**NEW DESIGN OIL COOLER
FOR CUMMINS® ISX/QSX ENGINES**

A2892304 Oil Cooler Core for ISX/QSX engines is available from AFA!

BUL0031

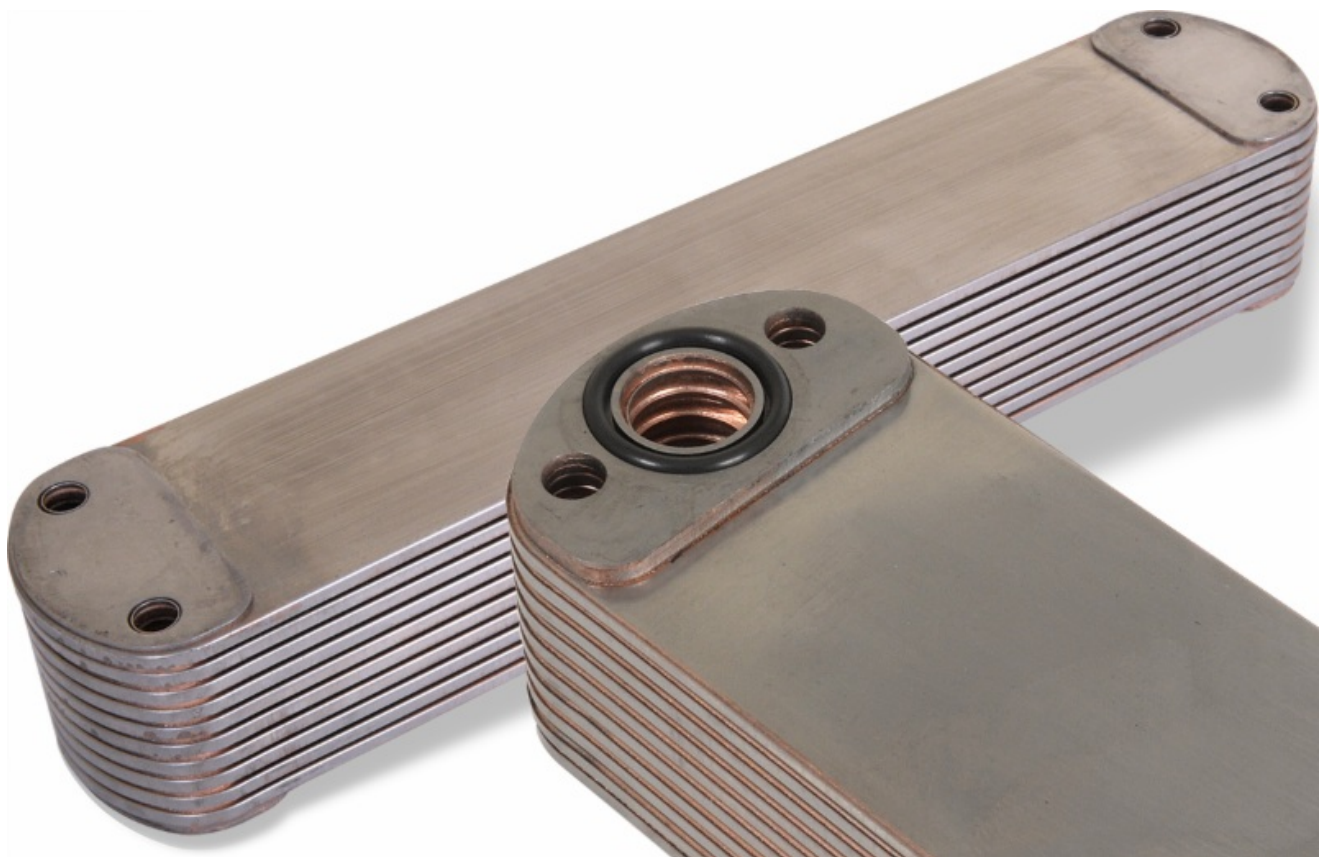
Cummins has redesigned the oil cooler for its ISX/QSX engines. The new design Part No. A2892304 utilizes O-Ring Seals and has a stainless steel oil cooler element. The old design Part No. A4965870 used Rubber Edge Molded (REM) style gaskets and had an Aluminum oil cooler element.

Cummins also recommends that because of the new design O-ring sealing method, part of the mounting hole becomes exposed and should be sealed with a chemical resistant, anaerobic sealer on the threads of the oil cooler mounting bolts.

YOU MUST USE TWO (2) OF O-RING PART NUMBER A4966084 IN ORDER TO SEAL THE NEW DESIGN COOLER A2892304 CORRECTLY.
